Re: Part VIII Planning Report for the Brewhouse Building.

Report – 12th December 2017

Abbey Quarter Brewhouse Project

8.0 Comparison of Amendments

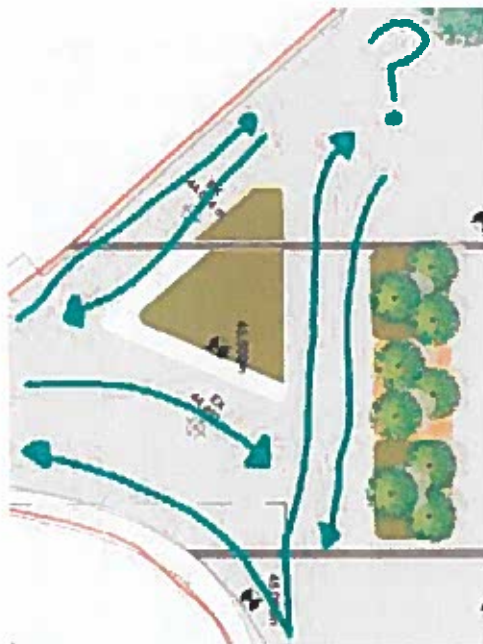
How are cyclists going to “flow” through the site? A particular example is the triangle in the plans, about where the guard station is today. Here is our sketch of ways cyclists might move through the site. But where do they go in the direction of the Abbey? There will be cycle access to the liner park, and hopefully St. Francis Bridge, so I am sure people will want to cycle through this area. Is there enough space around this triangle?

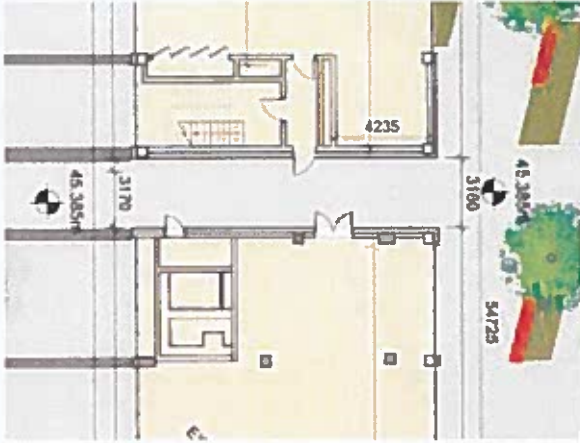
The third issue we note is with the lane between the buildings. There are no windows on it. It's a narrow lane, with only a few doors on it. This is the sort of area that lends itself to anti-social behaviour. Would it be

possible to add some windows into the lane?

PROPOSED AMENDMENTS TO GROUND FLOOR

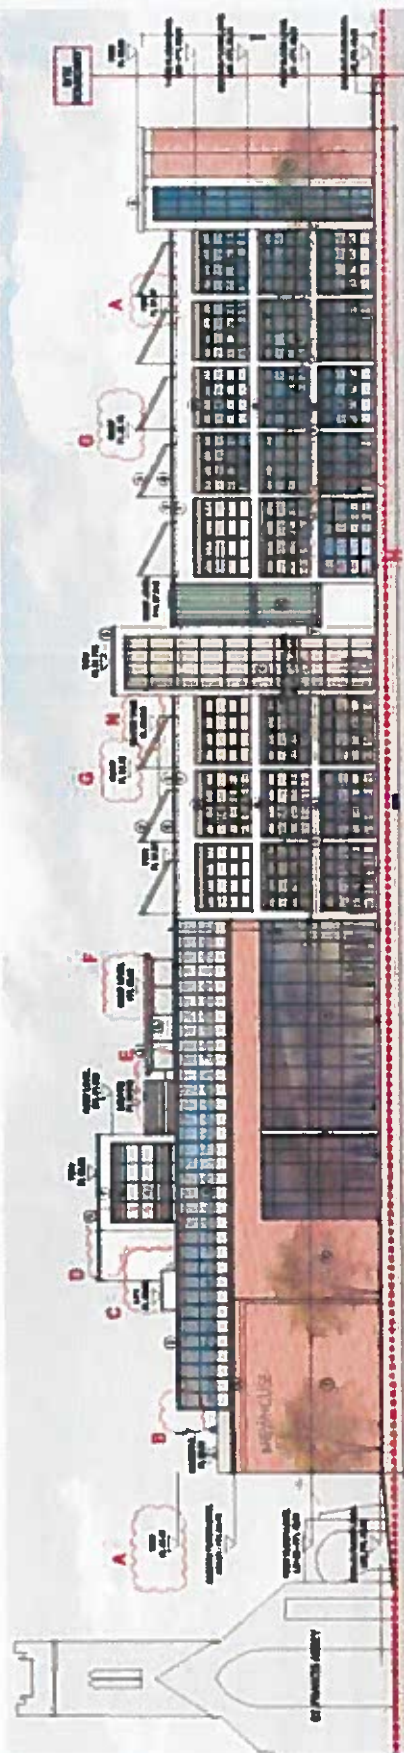
- A Roof Heights and Levels Modified
- B Balcony Modified Roof Overhang Omitted
- C Lift Moved to New Location
- D Existing 1 profile of Plinthroom Rerouted
- E Platform to Accommodate Equipment, Screened with Metal Cladding
- F Roof Light Modified
- G Sanitosh Roof Modified
- H ESB Substation Relocated Bay Rerouted 1m into Facade
- J External Landscape Levels Modified

PROPOSED AMENDMENTS TO WEST ELVATION

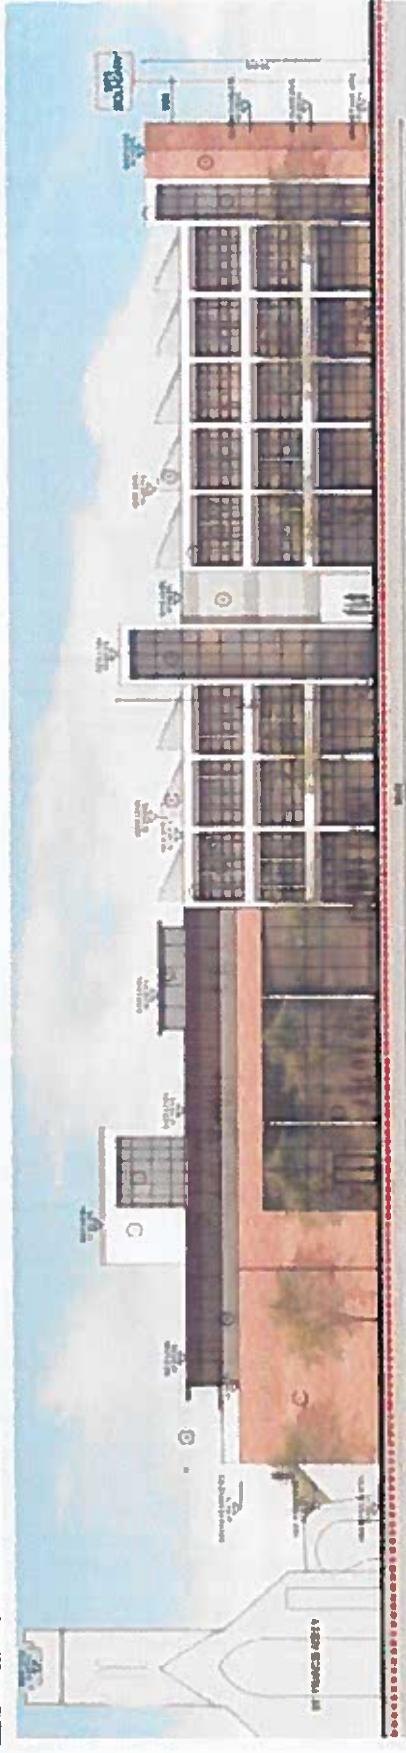
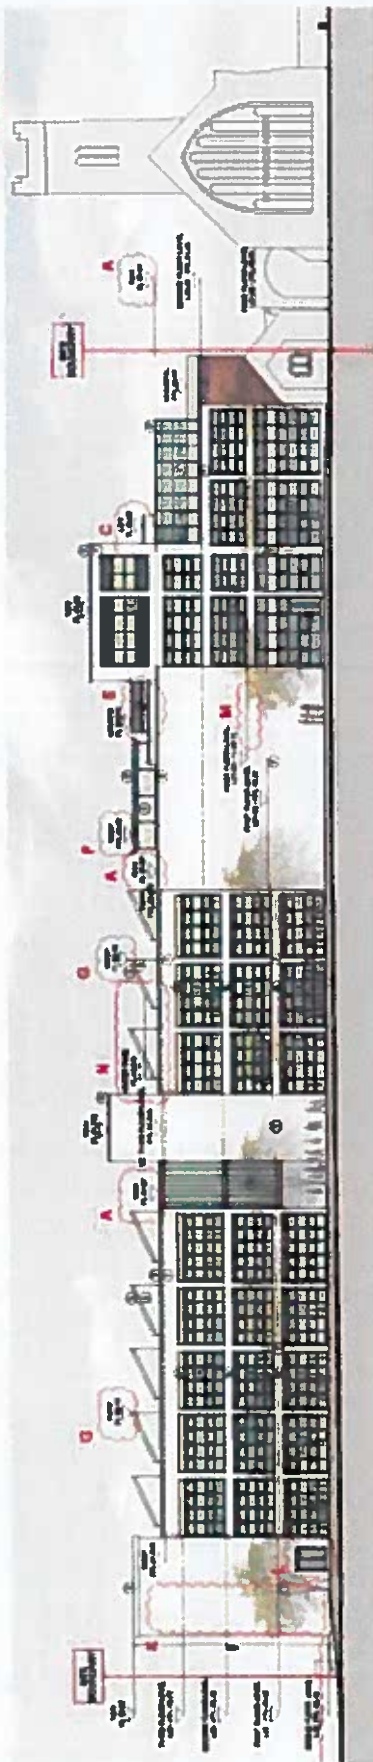
- A Roof Heights and Levels Modified
- B Balcony Modified. Roof Overhang Omitted.
- C Lift Moved to New Location
- D Existing L profile of Plinthium Reinstated
- E Platform to Accommodate Equipment. Screened with Metal Cladding
- F Roof Light Modified
- G Sawtooth Roof Modified

- H ESB Substation Relocated Bay Reversed (in into Facade)
- J External Landscape Levels Modified
- K Windows Removed
- L Door added
- M Existing Floor Retained Floor Level Modified
- N Water Tank. Screened Behind Sawtooth Roof Structure
- P Facade Updated to Reflect Existing Column Grid Structure
- Q Facade Updated to Reflect Internal IWC Core Modifications
- R External Balcony Added

PROPOSED AMENDMENTS TO EAST ELEVATION

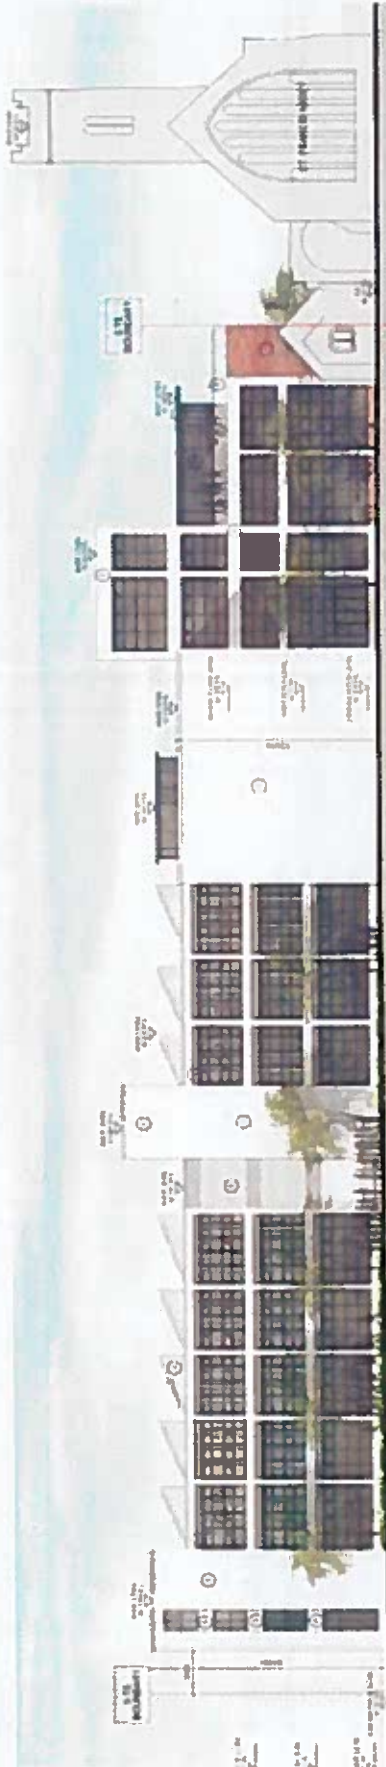
- A Roof Heights and Levels Modified
- B Balcony Modified Roof Overhang Omitted
- C Lift Moved to New Location
- D Existing Lymbria of Plinthroom Reinstated
- E Perform to Accommodate Equipment Screened with Alloys/Cladding
- F Roof Light Modified
- G Sawtooth Roof Modified

- H ESB Substation Relocated Bay Recessed 1m into Facade
- I External Landscaping Levels Modified
- K Windows Removed
- L Door added
- M Existing Floor Retained Floor Level Modified
- N Water Tank Screened Behind Sawtooth Roof Structure
- P Facade Updated to Reflect Existing Column Grid Structure
- Q Facade Updated to Reflect Internal WC Core Modifications
- R External Balcony Modified
